# ADDENDUM

**ADDENDUM NO.:** 001  
**PROJECT NAME:** CANTY ELEMENTARY SCHOOL ANNEX  
**PROJECT NO.:** 05750  
**CONTRACT NO.:** C1568  
**DATE OF ISSUE:** May 28, 2015

## NOTICE OF CHANGES, MODIFICATIONS, OR CLARIFICATIONS TO CONTRACT DOCUMENTS

Sheet  
C4.0

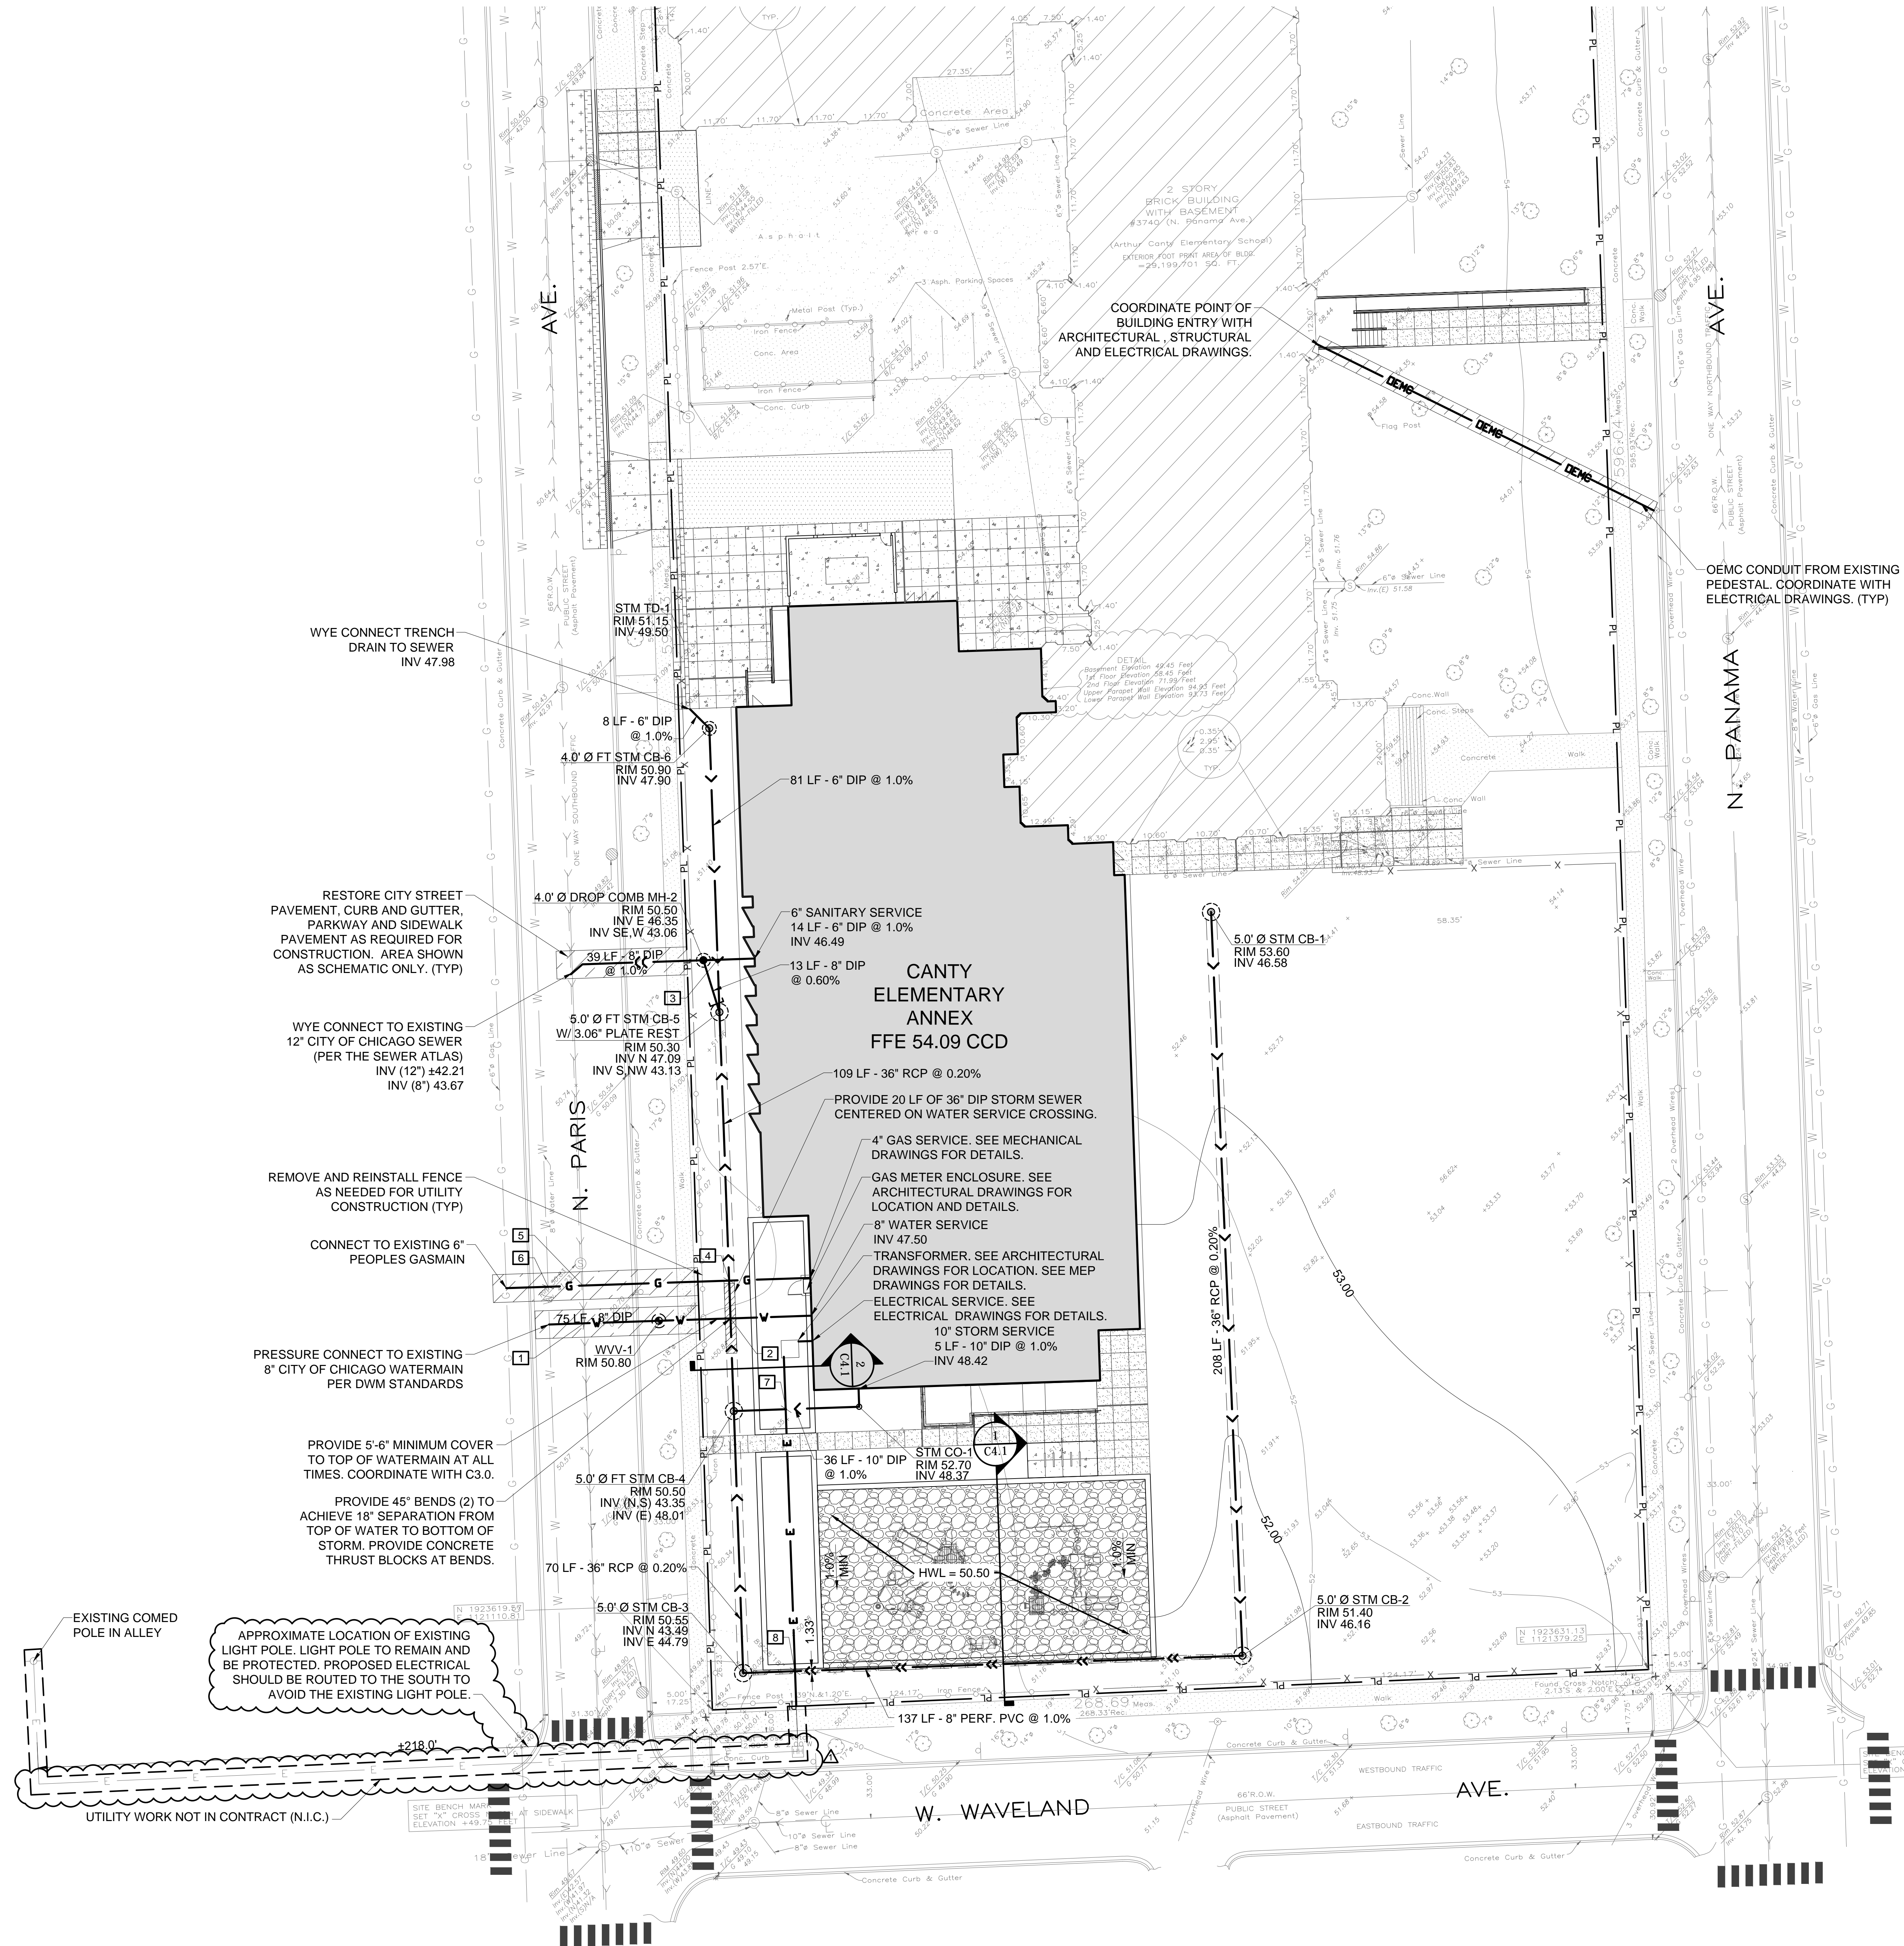
1. Sheet C4.0 Site Utility Plan
  - a. Addition of size of the proposed electrical ductbank, 21" x 13", in the utility crossing table.
  - b. Revision of location of the proposed electrical ductbank in relation to the proposed storm system in the utility crossing table. Proposed electrical ductbank is to pass under the proposed storm system with 12" of clearance.

**H8 ROOF CONSTRUCTION**  
 3" = 1'-0"

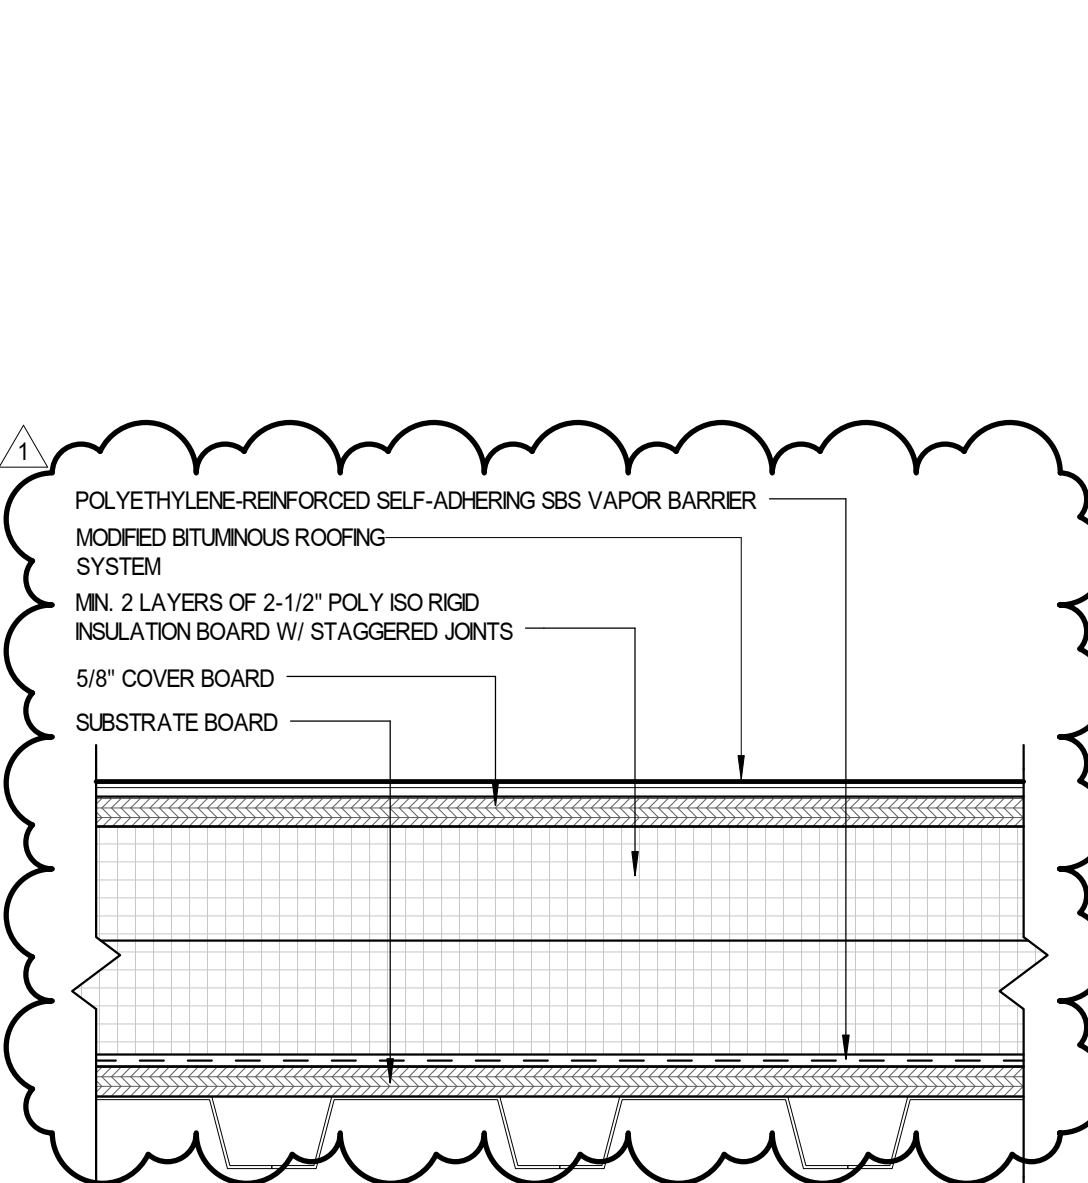
3. Sheet A-440 Roof Details
  - a. Detail H6 removed.
  - b. Detail H8 revised to coordinate with specifications.
  - c. All references to single-ply roofing system to be deleted.

Sheet  
**A-500**

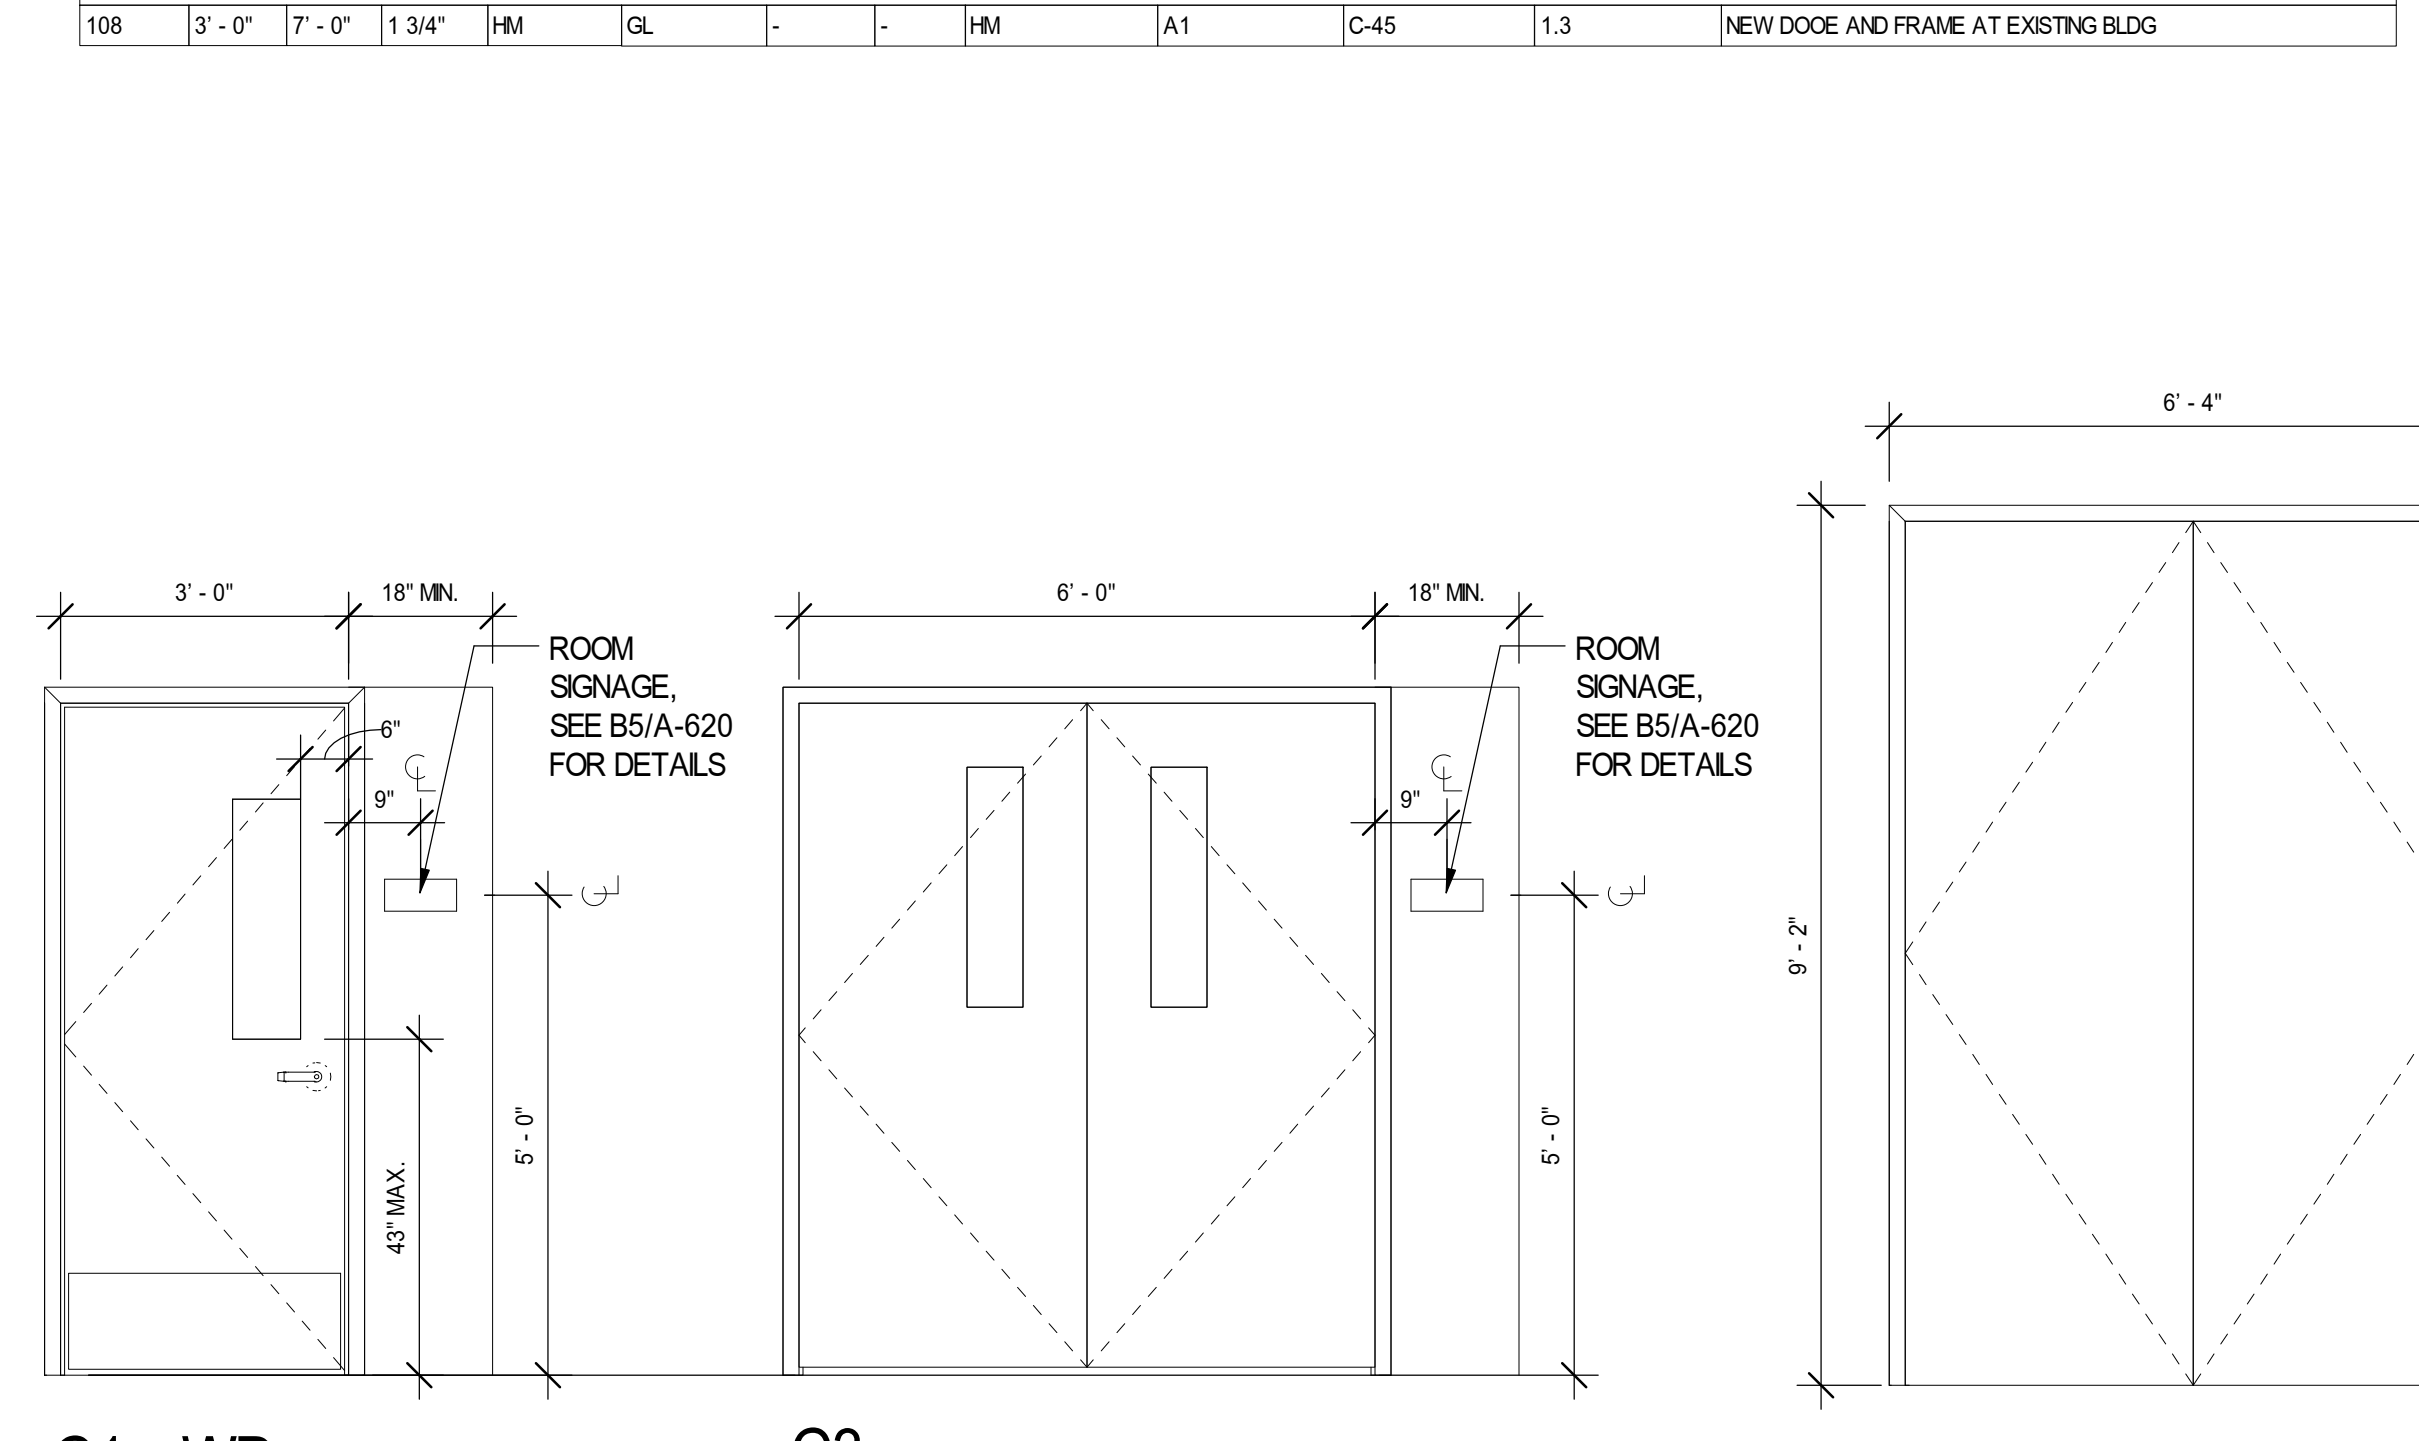
4. Sheet A-451 Exterior Details
  - a. Detail H10 removed.
5. Sheet A-500 Door Schedule Types and Details
  - a. Door schedule updated to coordinate with exterior elevations.

- b. Detail H10 door elevations updated to coordinate with exterior elevations and door schedule.
6. Sheet A-510 Partition Types and Window Schedule
  - a. Detail C1 Partition, add note "ASSEMBLY E – 2 LAYERS OF GWB ON SEPARATE ROWS OF INDEPENDENT METAL STUDS SEPARATED BY 1" MIN GAP ERECTED FULL HEIGHT TO STRUCTURAL SLAB ABOVE AND BELOW. FULL DEPTH ACOUSTICAL BATT INSULATION IN BOTH STUD CAVITIES. NO PENETRATIONS ALLOWED."
